Applications 2016/0255/P and 2016/0489/P,
117 Kentish Town Road: response

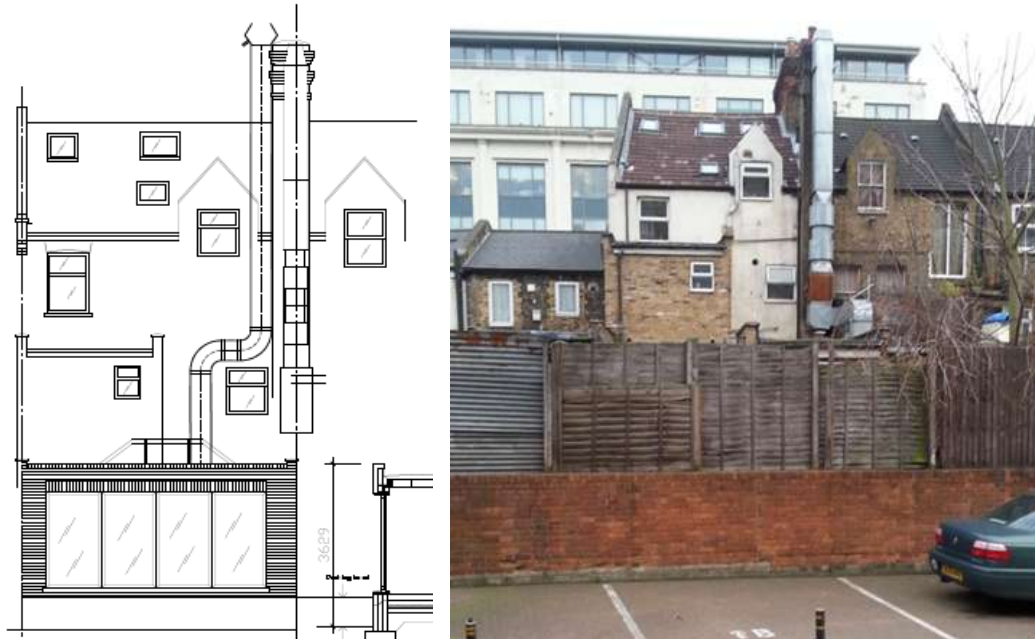
- *Show equipment, ducting and acoustic enclosures or screening on plans, elevations and sections* – is sufficient information provided?
- *Show the location of neighbouring windows on drawings cross referenced to the acoustic report* – what attempt has been made on this?

The Acoustic Report has significant deficiencies:

1. The report does not include restaurant ambient noise 'because the restaurant is not open yet'. Yet the application proposes to allow guests into the open back garden 'to smoke'. What estimate was made of this noise?

2. The report does not describe receptor sensitivity because 'the distance of the nearest dwelling has not been determined'. Yet, there are clearly known residences in the upper floors of No. 117 and neighbouring buildings.

3. The report has made recordings in the back garden 'deemed to be similar to those at the proposed ventilation outlet', yet the consultant did not erect a ladder to measure at the actual position proposed for the end of the vent.

4. The report mentions casually "An air conditioning unit positioned at the rear of the neighbouring 119 Kentish Town Road contributed to the ambient noise levels." [Assume this is a mistake – it is No. 115 which has the chimney, from a restaurant kitchen, not No. 119.] The gardens back onto open space of the estate, which has low noise levels (no cars). Could closely adjacent ventilation pipes produce 'beats' or other potentiation?

5. The report says "the least attenuation will be at the location of the fan inside the building" but gives no estimate of this location internal noise impact on staff and customers.

6. The report assumes continuous use but this is not necessarily optimum for energy efficiency and cost. What is the probability of irregular use?

CPG 1 Ensuring good Design: shopfronts

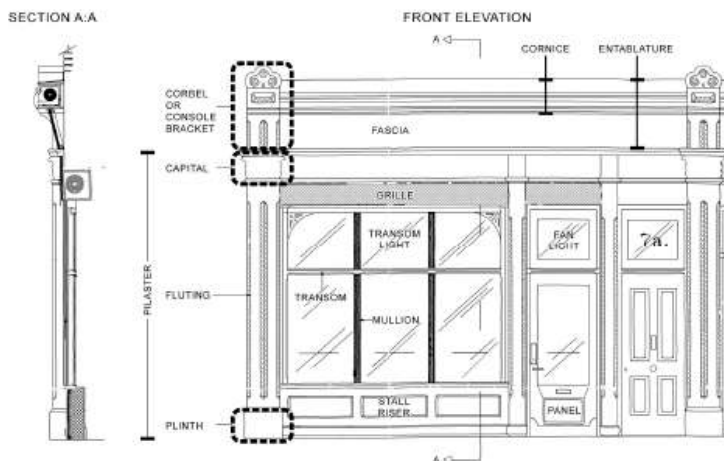
The proposed shop front does not meet Camden's guidance, and should reflect the 200-year history of this line of buildings (Providence Place) which were not demolished at the widening of the road in 1880 (compared with those opposite).

- Pilasters and corbels should be placed on both sides, in line with solid wall, to emphasise their function
- Stallrisers (solid elements below shop windows... at least 300mm high) should be ... incorporated
- “*Folding shopfronts are not generally acceptable ... they erode the appearance of the shopfront, and can increase disturbance to neighbouring properties, particularly in the case of food and drink premises*”.

The proposed folding windows must be rejected.

The application form says the windows will be PVC. In this building of around 150 years age, adjacent to locally listed buildings (Providence Place) and proximal to three conservation areas (Jefferys, Rochester, Kelly), the original windows were wood: the replacements should also be wood. PVC has poor visual impact – both inside the restaurant and for external views.
